A G E N D A

Architectural Review Board

September 22, 2020 – 5:30 p.m.

↖ ↗

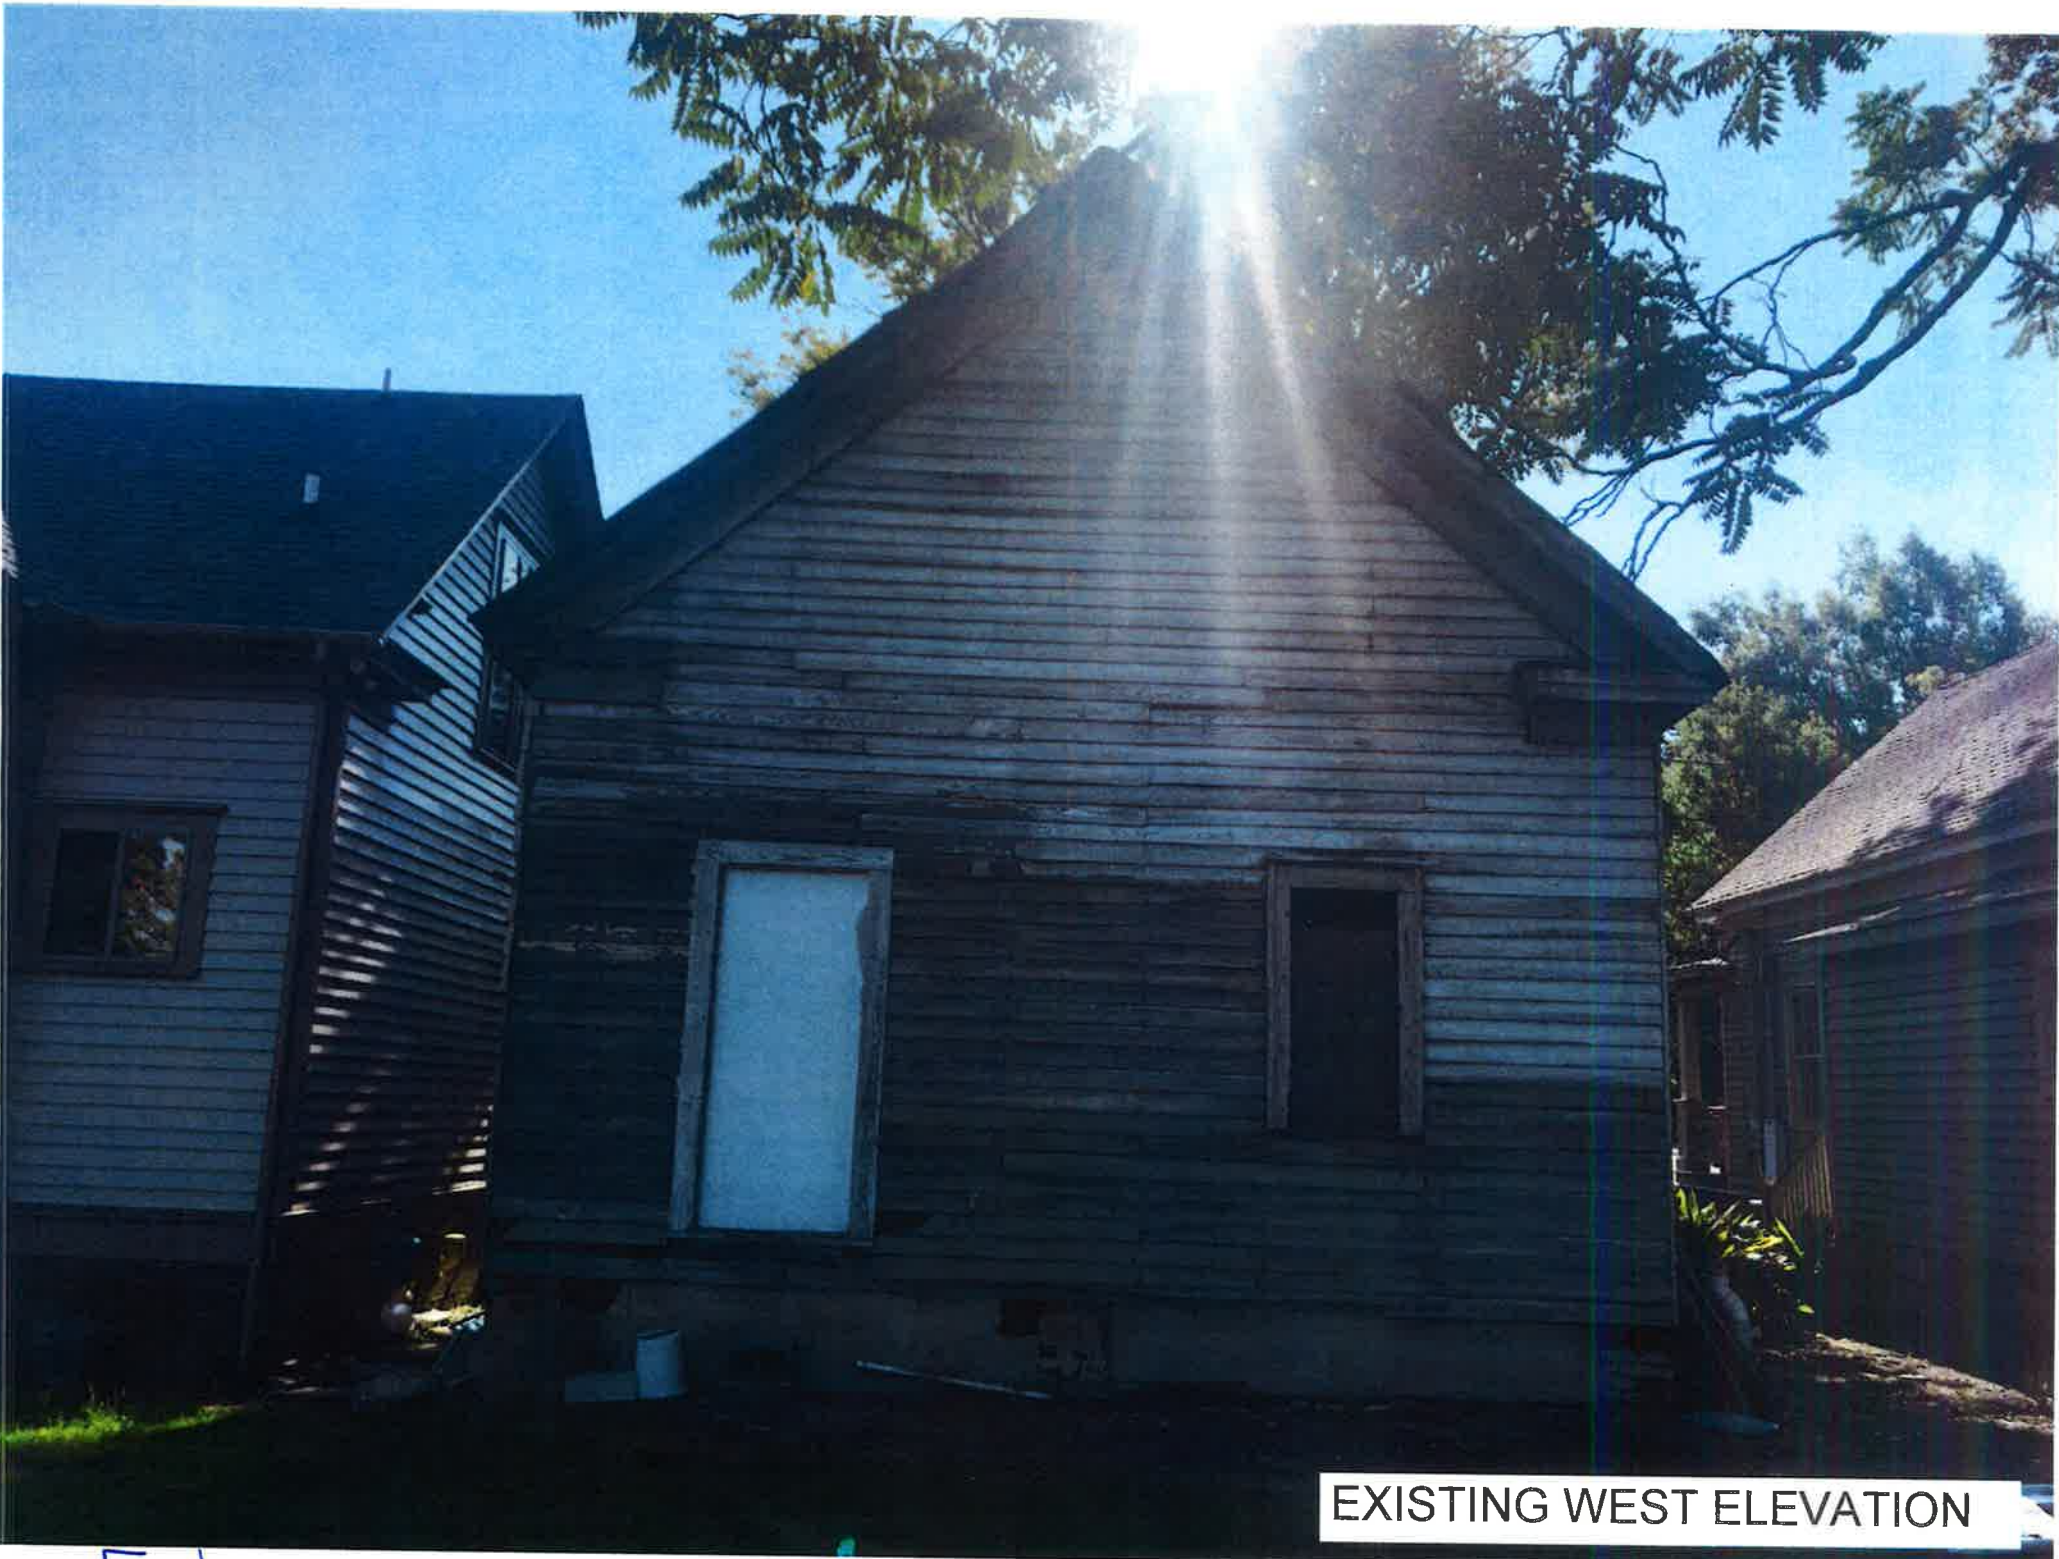
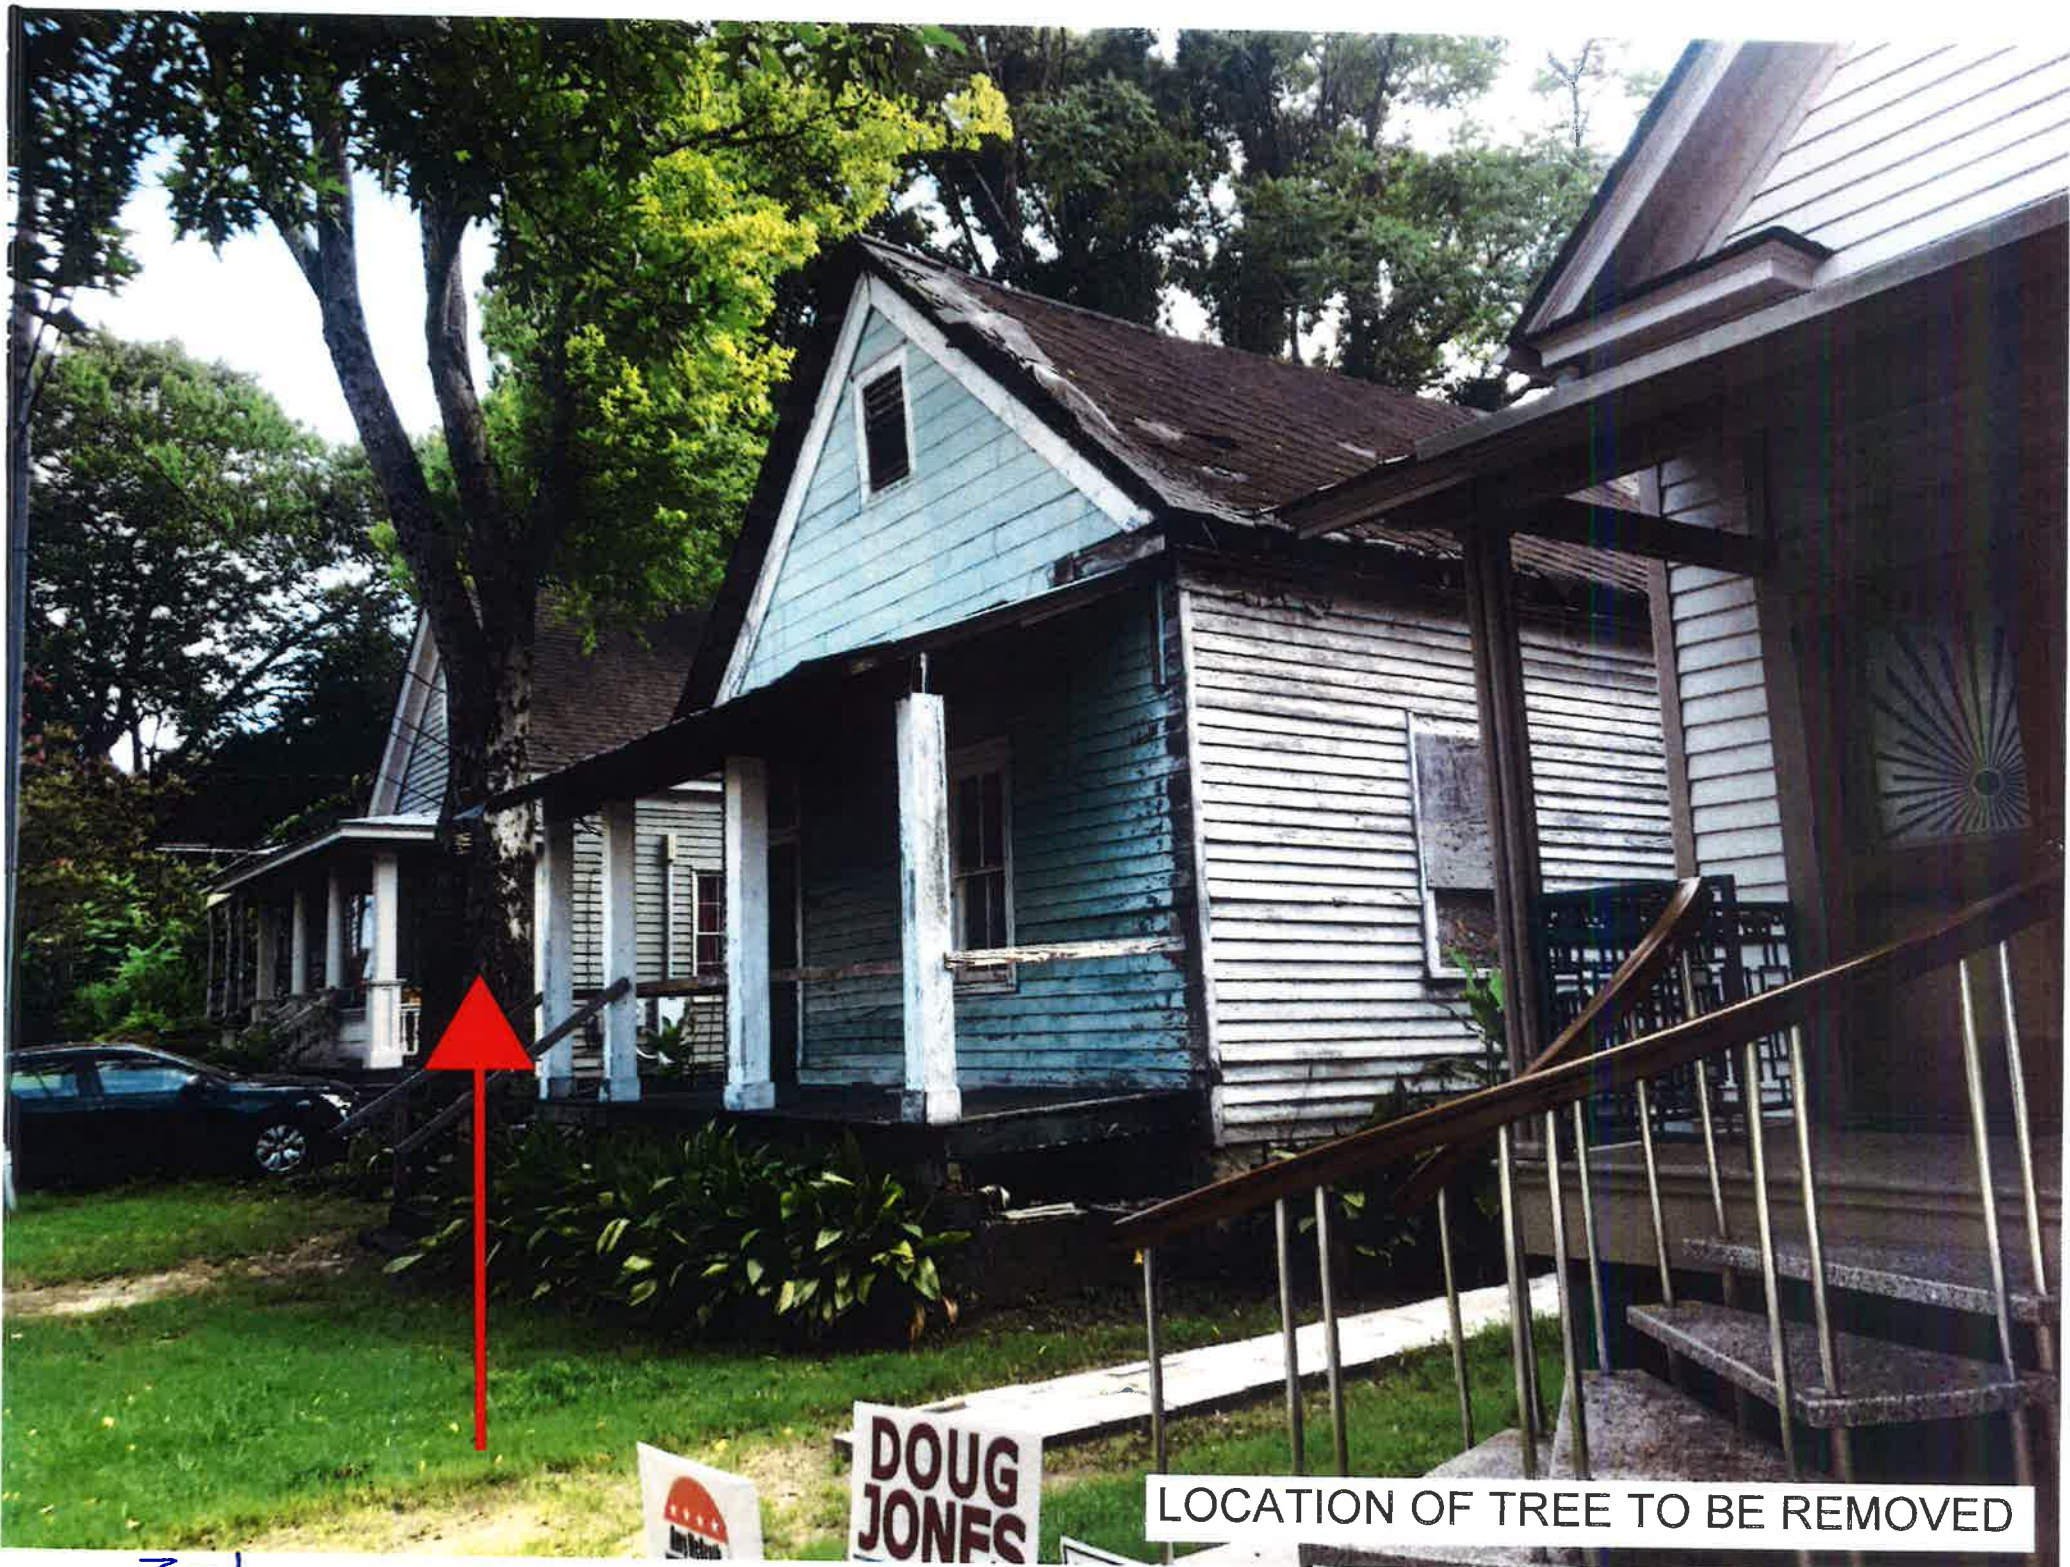
- The Board approved a similar petition (including the tree removal without replacement due to lack of space) in January 2020 for the previous owner.
- The Board has approved the use of cementitious siding on additions, it does help differentiate the original structure from the addition as recommended by the Secretary of the Interior's Standards.
- The Board has approved metal roofs in traditional crimps (e.g. 5-v) on porch roofs and slopes where only a rolled roofing material could be used.
- Aluminum clad simulated divided lite windows have been approved as replacements as they maintain a permanent grid on the glass.

8A

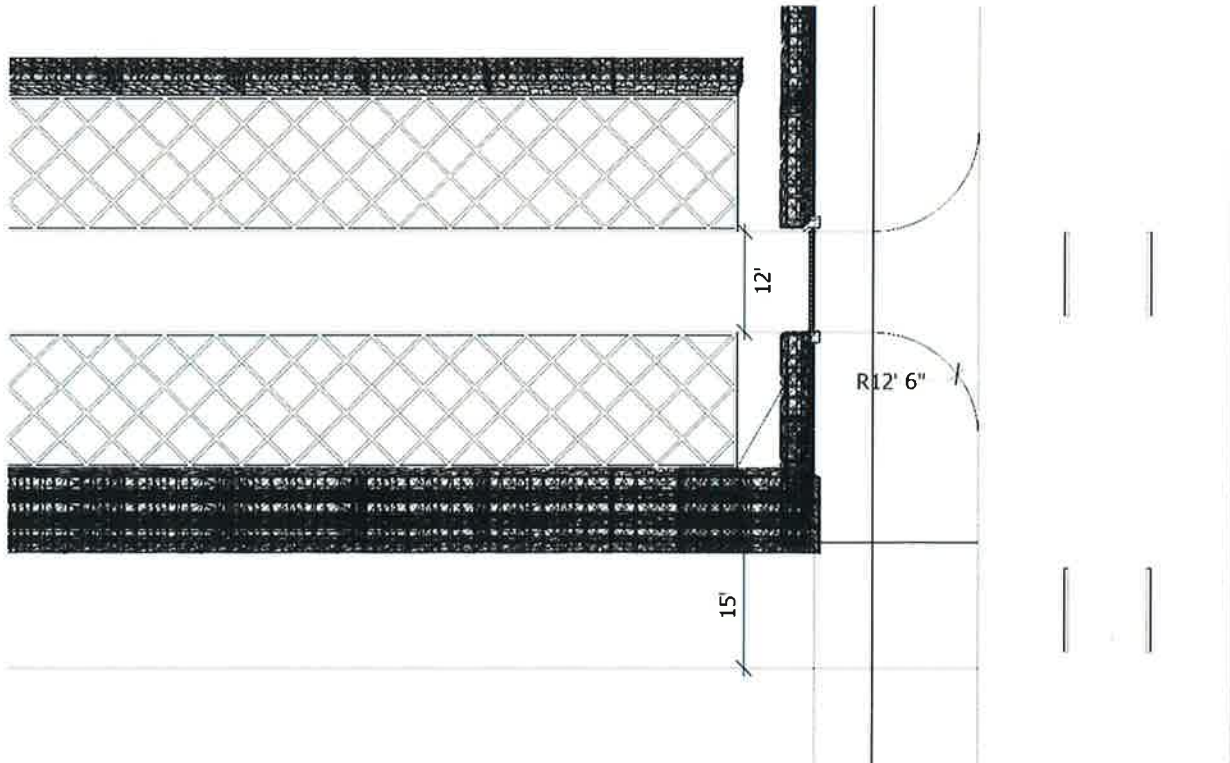
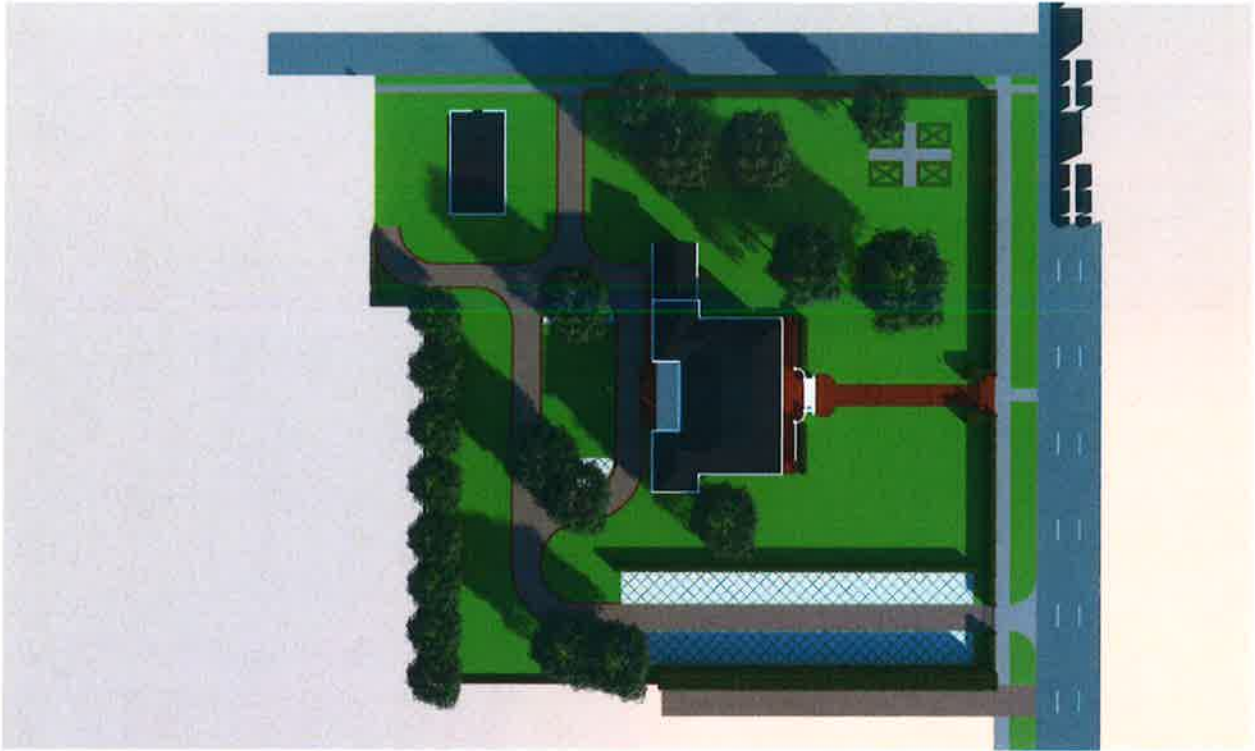
- The goal is to preserve a residential feel on a larger/estate lot while accommodating the proposed use as an event space. The Board needs to consider whether the proposed 8' hedge screening and the proposed parking pave/grass combination helps maintain that appearance.
- A 3' front yard fence is a polite and historically appropriate front fence height.

9F

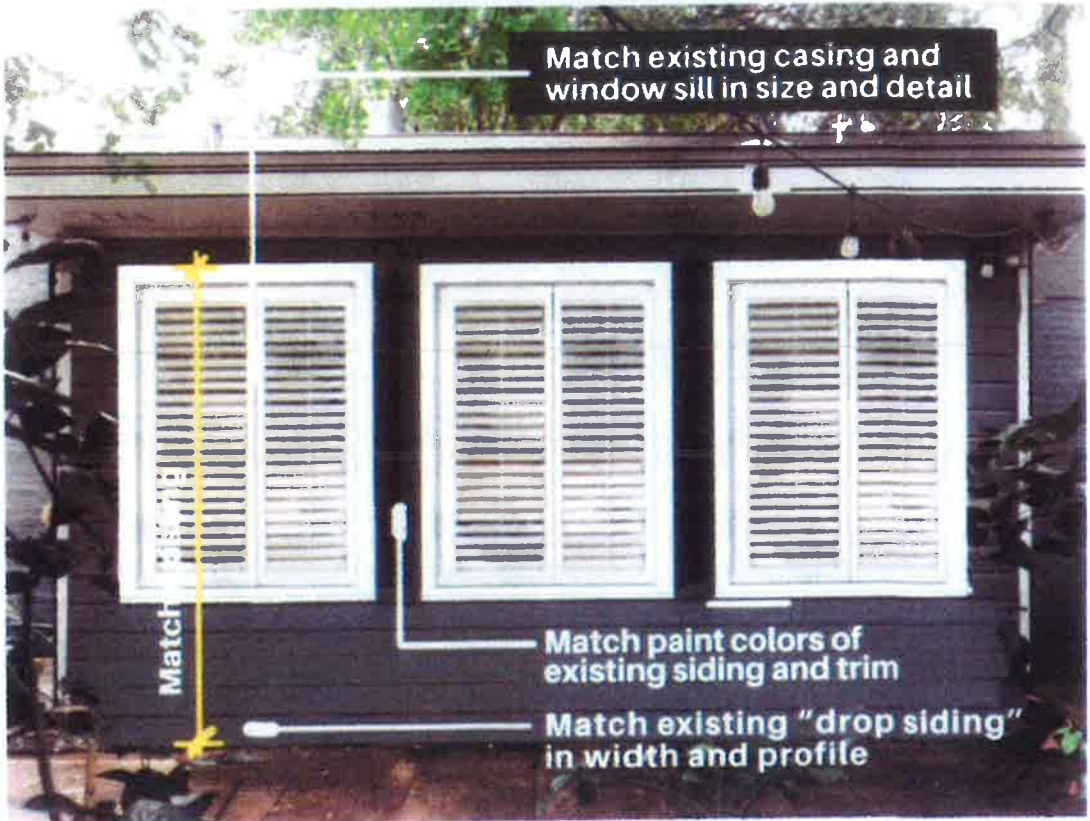
- Staff has confirmed that the additions will not encroach into any required setbacks.
- The additions will not be visible from Magnolia Curve or Westmoreland, no objection.
